## AIRTEK RIDE HEIGHT ADJUSTMENT PROCEDURE

SUBJECT: AIRTEK™ for Freightliner Vehicles

LIT NO: SEU-0211

#### AIRTEK™ REVISED RIDE HEIGHT ADJUSTMENT PROCEDURE

Figure 1

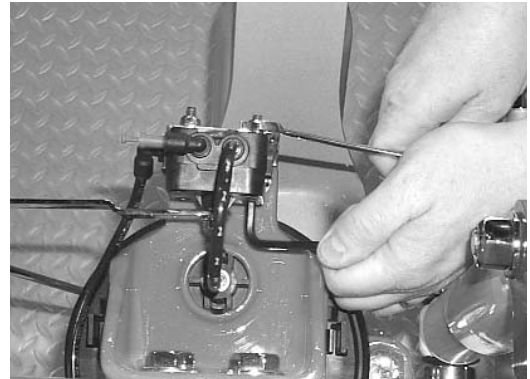
Hendrickson has learned of a potential service issue regarding the height control valve on vehicles equipped with the AIRTEK suspension. After performing a ride height adjustment procedure, the bottom socket head cap screws may loosen up if the 1/4" height control valve mounting locknuts are not properly re-tightened. Loose cap screws may cause an air leak between the two halves of the height control valve body. Such an air leak may affect suspension performance and proper operation of air system components in the suspension.

Hendrickson recommends the following be performed during any type of ride height adjustment to help prevent socket head cap screws from loosening from the height control valve housing, and any subsequent air leaks from the height control valve.

1. Prior to adjusting the height control valve, clean the threads of the 1/4" fasteners of any debris and corrosion.
2. After the adjustment is made, install a 3/16" allen wrench in the bottom socket head cap screws to prevent the screws from turning while re-tightening the 1/4" locknuts. See Figure 1.
3. Re-tighten the locknuts to 7-10 foot pounds torque. See Figure 2.
